FJ CRUISER

OUTLINE OF NEW FEATURES

The following changes have been made for the 2010 model year.

2. 1GR-FE Engine

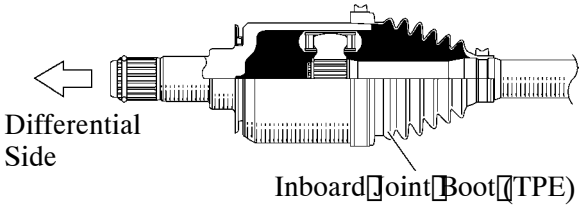
Changes from the '09 FJ Cruiser 1GR-FE engine mainly consist of some parts around the cylinder head. For details, see page 5.

4. Front Drive Shaft

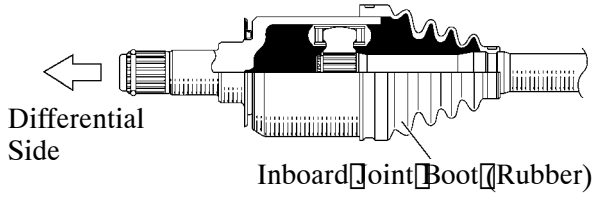
The inboard joint boot of the front drive shaft has been changed from rubber to Thermoplastic Elastomer (TPE) to make it more lightweight.

7. Steering

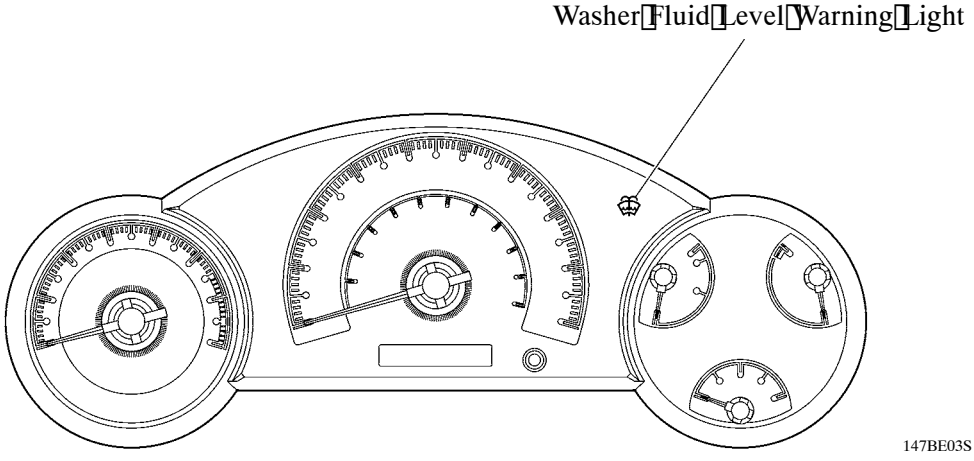
The shape and characteristics of the steering gear and the vane pump have been changed. For details, see page 45.

10. Washer

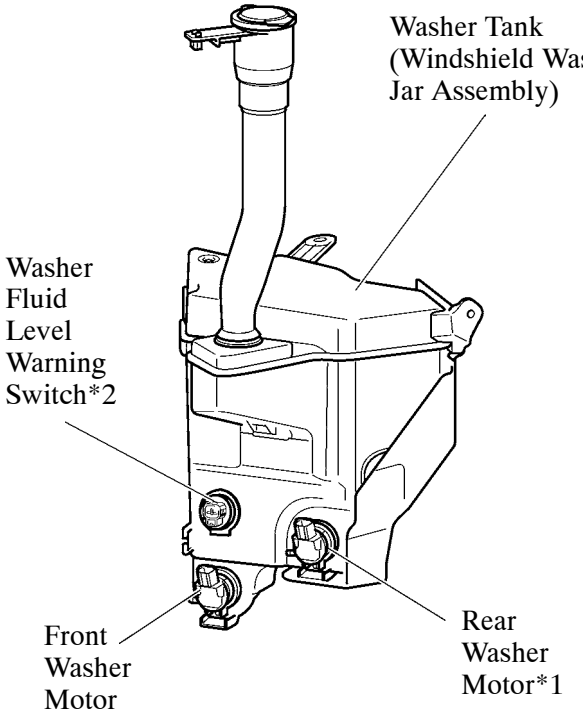
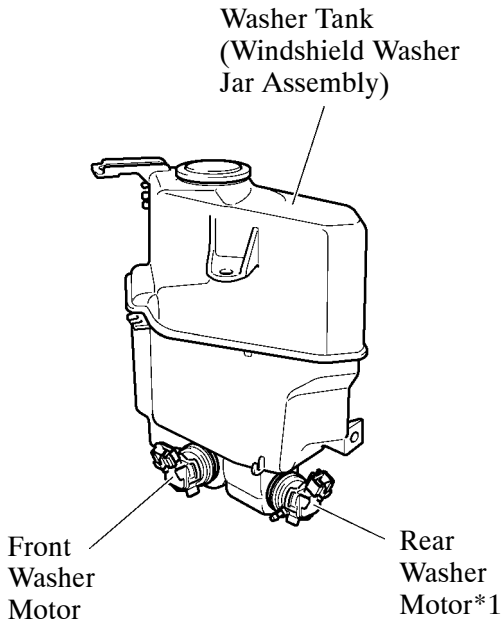
- Along with the changes to the engine air cleaner, the washer tank configuration has been changed and its installation location has been moved from inside the engine room to below the front fender apron RH.
- The washer fluid level warning switch is used on models for Canada.
